METROPOLITAN GOVERNMENT OF NASHVILLE AND DAVIDSON COUNTY

STAFF RECOMMENDATION
1520 Woodland Street
October 17, 2012

Application: New construction—addition
District: Lockeland Springs-East End Neighborhood Conservation Zoning Overlay
Council District: 06
Map and Parcel Number: 08309047100
Applicant: Jeff Casella, architect
Project Lead: Robin Zeigler, robin.zeigler@nashville.gov

<p>Description of Project: Application is to construct a side, open-air, covered dining space.</p> <p>Recommendation Summary: Staff recommends approval of the project finding it to meet Section II.B. of the <i>Lockeland Springs-East End Neighborhood Conservation Zoning Overlay: Handbook and Design Guidelines</i>.</p> <p>Recommendation of this project will provide guidance for future similar requests of open-air additions to commercial buildings. Such applications may be appropriate if: the addition is located on the ground level off a secondary facade, is not located on a street facing side of a building, has a permanent glass wall on the portion of the addition which faces the street, and the front sits back a minimum of three (3') from the front or side wall, depending on placement of the addition. The

WEST ELEVATION (RIGHT SIDE)

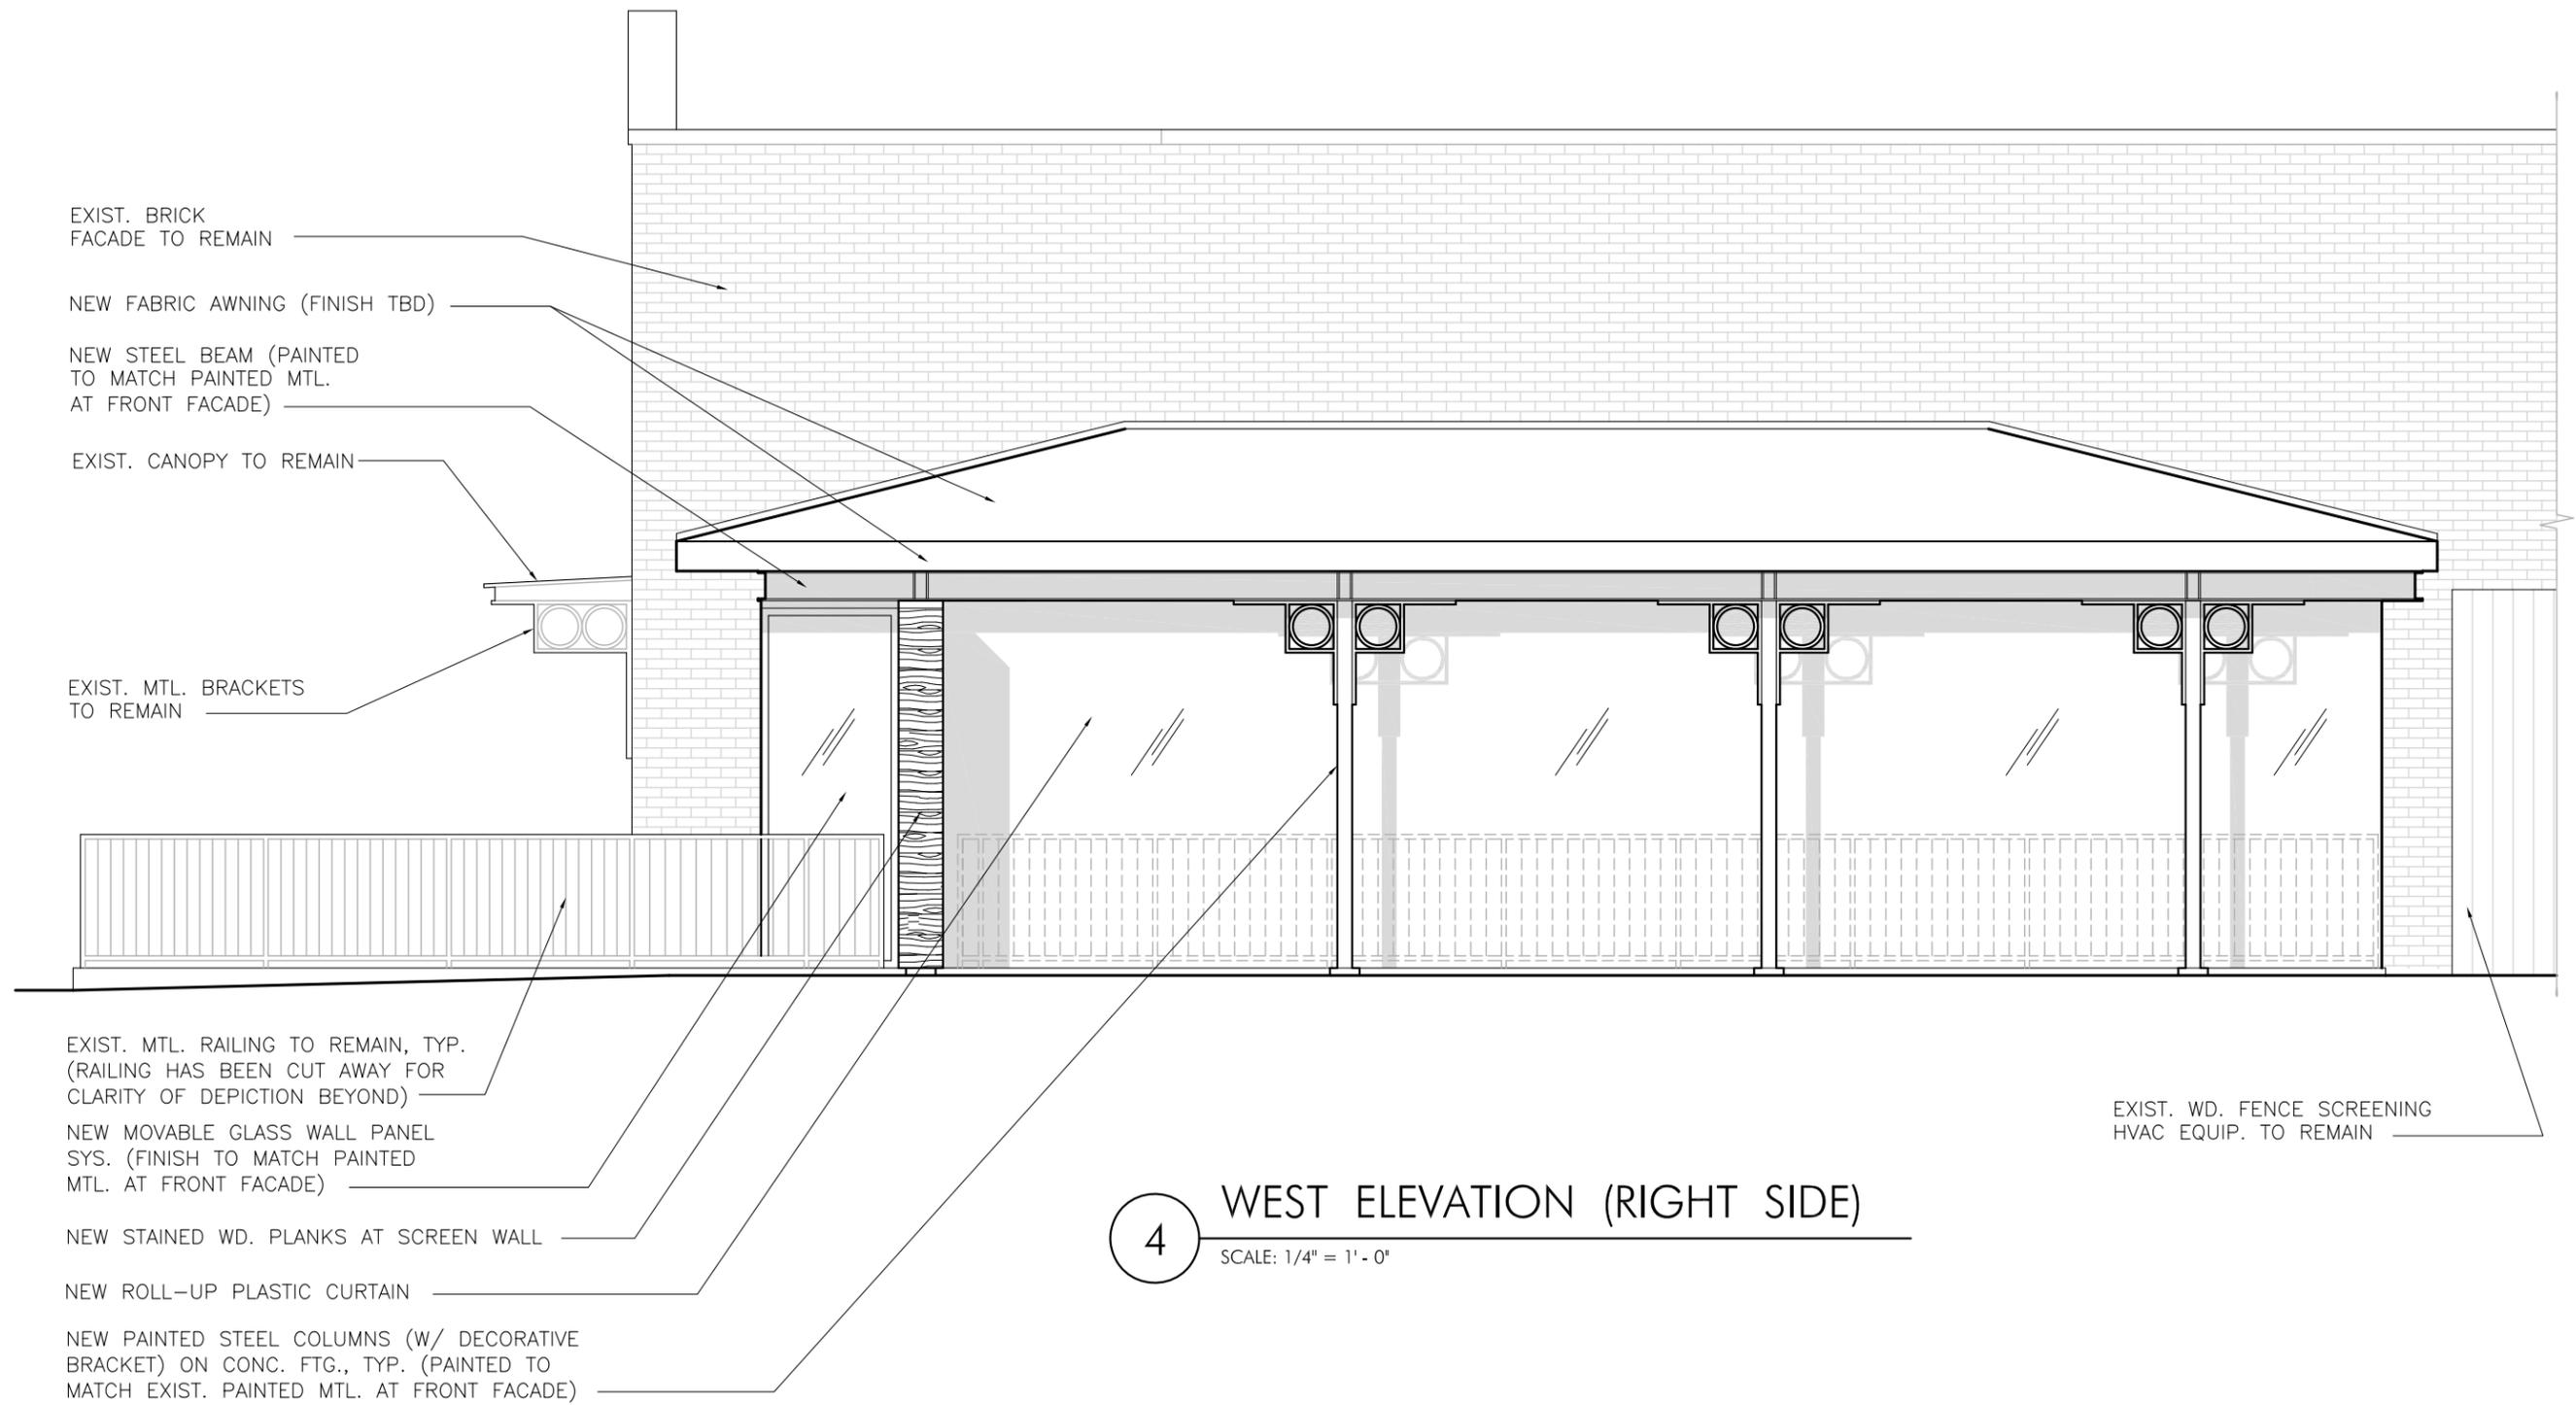
Height & Scale: The tallest portion of the covered addition is approximately nine feet (9') below the tallest portion of the parapet. When side additions are appropriate, they are required to be a minimum of two feet (2') below the ridge line, which this project more than meets. They are also required to be less than half the width of the front of the building. The project more than meets that requirement as well, since the addition is approximately eleven and one-half feet (11 ½) in width compared to approximately thirty-one feet (31') in width for the existing building.

Roof: The porch roof will be hipped with a similar slope to many historic buildings in the district. Staff finds addition's roof to meet Section II.B.5. and II.B.10. of the *Lockeland Springs-East End Neighborhood Conservation Zoning Overlay: Handbook and Design Guidelines*.

Materials, Texture, and Details and Material Color: Materials include glass wall panels with a finish that matches the existing storefront, a wood screen, and a canvas covered roof on a steel frame. The sides will have plastic roll-up sides that have been disapproved in highly visible locations for other projects. In this proposal, the addition will appear to have a more permanent front with the glass panels and wood screen that wraps the corner. The plastic sides will be minimally visible on the secondary elevation, when they are down.

Anticipating future requests, staff recommends allowing for plastic roll-up sides on commercial buildings with the following conditions: it is located on the ground level off a secondary facade, not be on a street facing side of a building, have a permanent glass wall on the portion of the addition which faces the street, and the front sits back a minimum of three (3') from the front or side wall, depending on placement of the addition. The reason for these conditions is to allow for minimal and open additions that provide temporary cover and discourage more permanent additions that have a greater visual impact on the building, while minimizing the impact of an inappropriate material, plastic.
